DATE:	ISSUE / REVISIONS:
06.18.2013	Site Plan Submittal
09.17.2013	Response to Staff Comments
10.29.2013	10/18 Staff Response
11.14.2014	Response 2.12.14 Comments
04.21.2017	Settlement Modification
07.19.2018	Arch. Elevation Revisions
08.06.2019	Class II Modification 2019

BLDG VI ELEVATIONS

A6.4

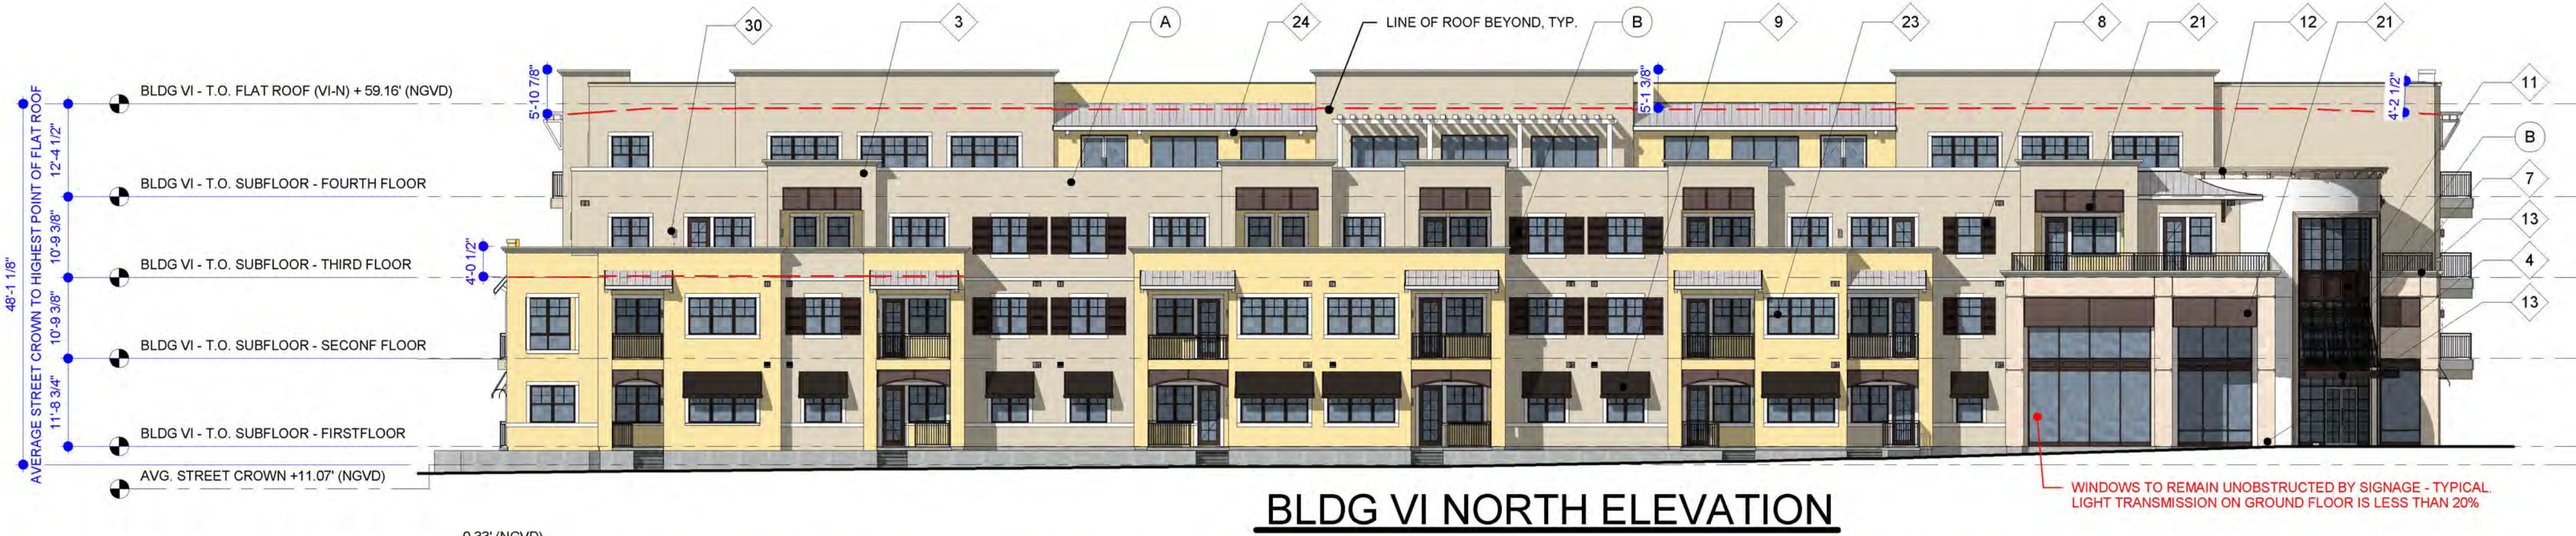
RESPONSE TO 2.12.14 STAFF COMMENTS
• BUILDING III NORTHWEST FOOTPRINT ADJUSTED DUE TO ADDITION OF RAMP AT NE 6TH AVENUE
• WINDOWS OF THE BUSINESSES AND OFFICES REMAIN UNOBSTRUCTED BY SIGNAGE
• LIGHT TRANSMISSION FOR GROUND FLOOR GLASS AREA TO BE NO GREATER THAN 20%
• KNOX BOXES TO BE PROVIDED AT ROLL DOWN GATES
• GREEN WALL IS CONSIDERED A TRELLIS WHICH SHALL BE ALLOWED TO ENCROACH INTO SETBACK ALONG FEDERAL HIGHWAY
• ADDED INGRESS/EGRESS RAMP AT NE 6TH AVE

SETTLEMENT MODIFICATION 4.21.2017
• ADD ARCADE ALONG THE NORTH ELEVATION
• ADJUST POSITION OF LOADING AREA
• ADJUST EAST AND WEST ELEVATIONS DUE TO ADDITION OF ARCADE.

ARCHITECTURAL ELEVATION REVISIONS 7.19.2018
GENERALLY REVISE ELEVATIONS TO BE MORE CONSISTENT WITH ANGLO CARIBBEAN, INCLUDING:
• SCULPTED FORMS AT ARCADE AND AT FEATURE ELEMENTS OF THE BUILDING
• RE-SCALE WINDOWS AT CORNERS
• WOOD DETAILING AS ACCENT AT VERTICAL FORMS
• ENTRANCE DETAIL AT BUILDING CAP
• RE-DETAIL ARCADE AND LOW ROOF FORMS

CLASS II MODIFICATION 2019 8.2.2019
• REVISE DETAIL AT ARCADE
• ADD TRELLIS BETWEEN III & VI-S

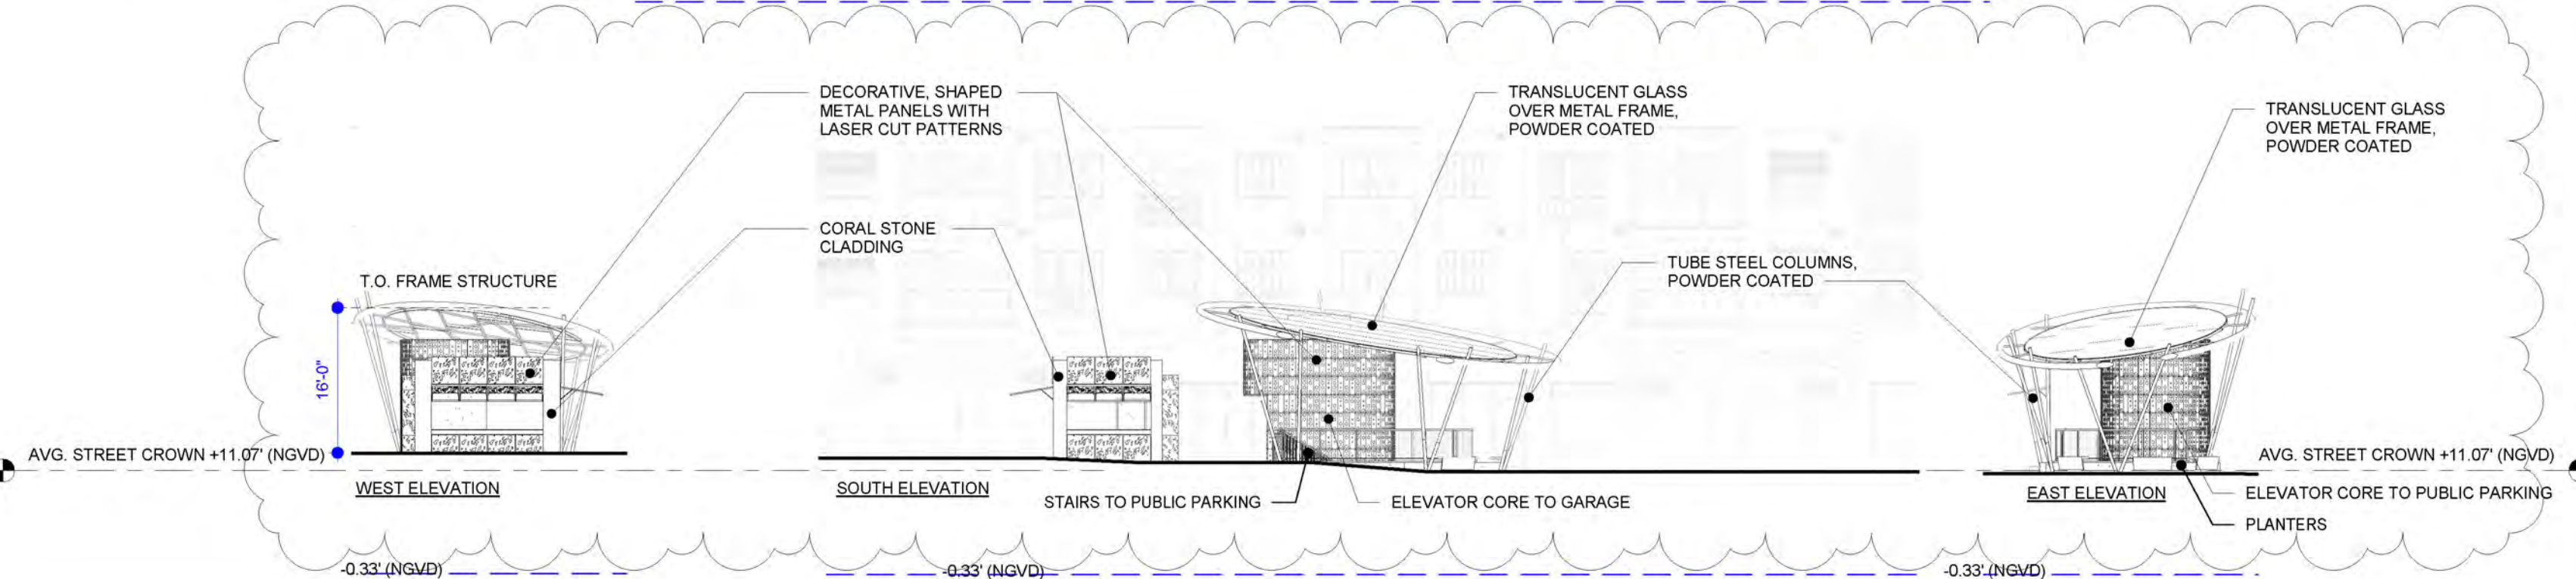
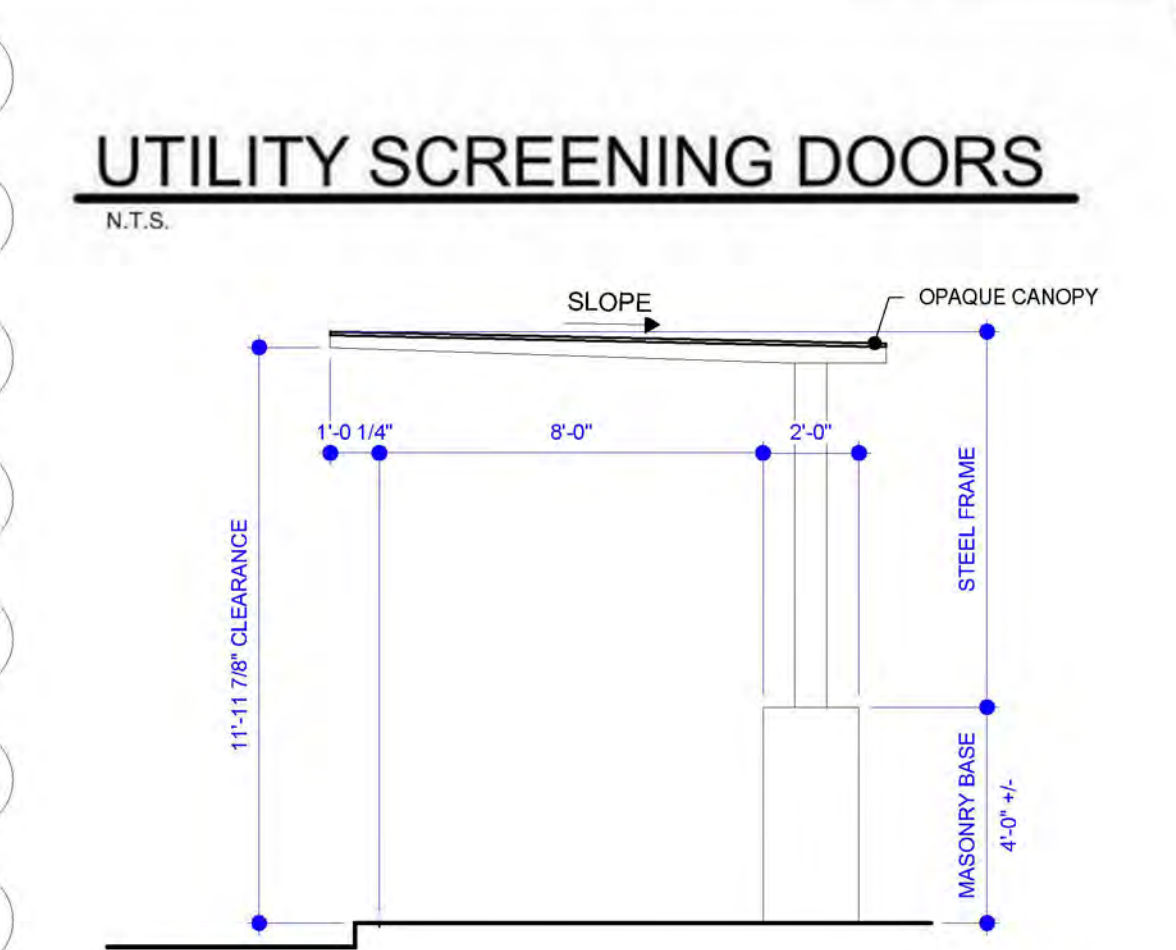
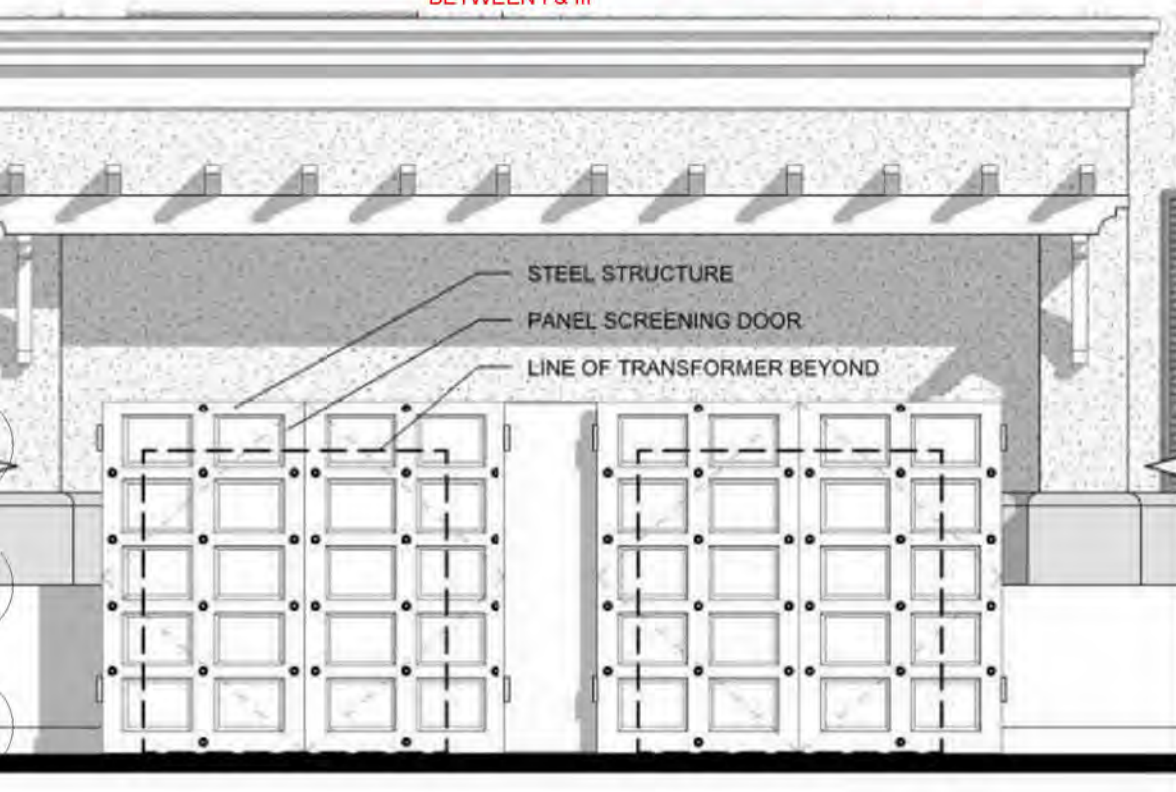
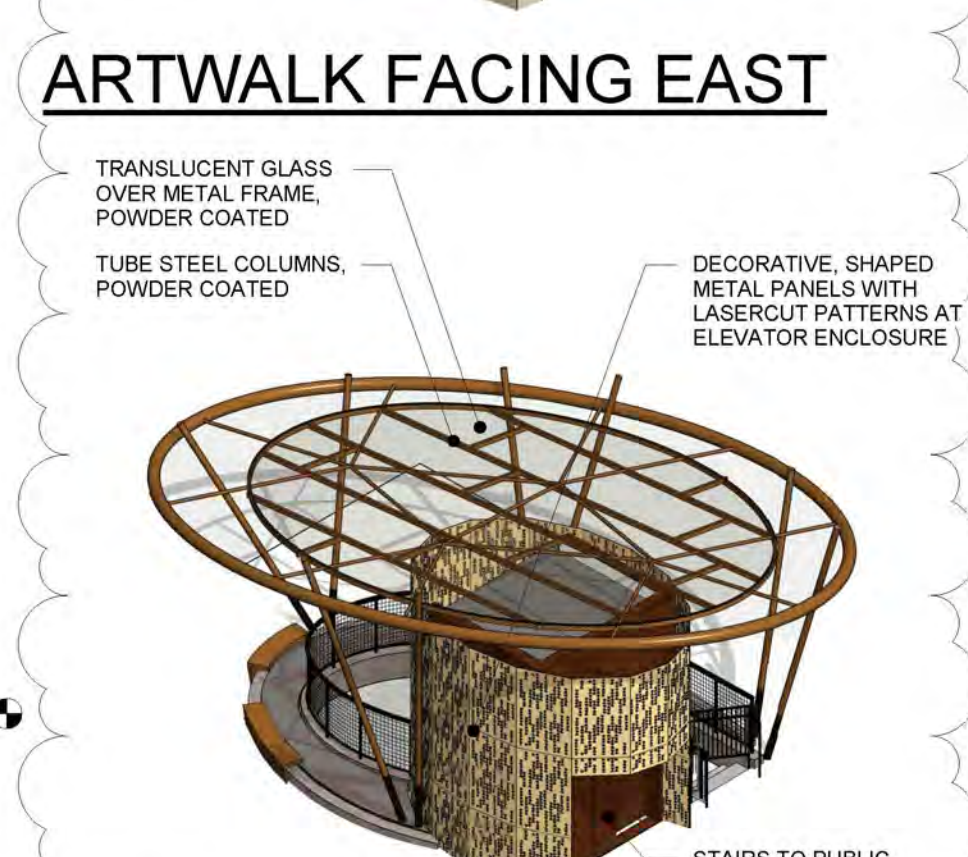
RESPONSE TO 2.12.14 STAFF COMMENTS
• WINDOWS OF THE BUSINESSES AND OFFICES REMAIN UNOBSTRUCTED BY SIGNAGE
• LIGHT TRANSMISSION FOR GROUND FLOOR GLASS AREA TO BE NO GREATER THAN 20%
• KNOX BOXES TO BE PROVIDED AT ROLL DOWN GATES
• ADJUSTED METAL AWNINGS AND ADDED MORE SHUTTERS

SETTLEMENT MODIFICATION 4.21.2017
• RELOCATED ENTRY TO PARKING GARAGE
• ADJUST EAST AND SOUTH DUE TO PARKING GARAGE ENTRY RELOCATION

ARCHITECTURAL ELEVATION REVISIONS 7.19.2018
GENERALLY REVISE ELEVATIONS TO BE MORE CONSISTENT WITH MASONRY MODERN, INCLUDING:
• STRENGTHENING PEDESTRIAN SCALE OF ENTRY TO LEASING (NORTH-WEST CORNER)
• ENHANCED HORIZONTAL DETAILING AT BASE - ADDED ROOF FORMS, CONSOLIDATED COLOR, MINIMIZED TALL SLENDER VERTICAL FORMS
• ENHANCE DETAILING AT BUILDING CORNERS
• ENHANCE DETAILING AT BUILDING CORNERS

CLASS II MODIFICATION 8.2.2019
• ADD TRELLIS BETWEEN III & VI-S
